# UNITED STATES PATENT AND TRADEMARK OFFICE

10/773,571

Martin E. Thiede

## **DETAILED ACTION**

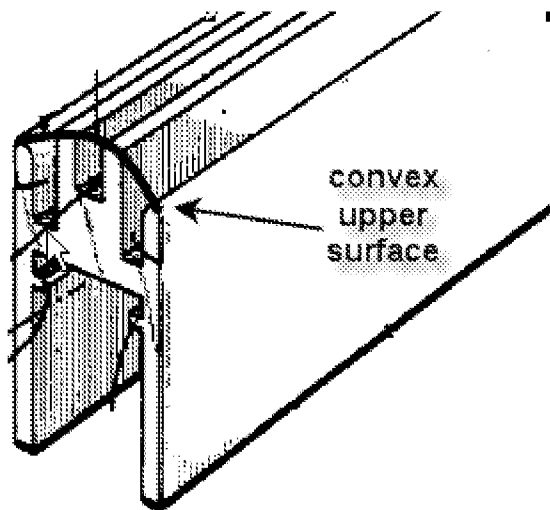
**Regarding claim 2**, Bessert discloses wherein the beam coupling structure presents a substantially convex upper surface configured to gravitationally support the floor coupling structure (See figure below).
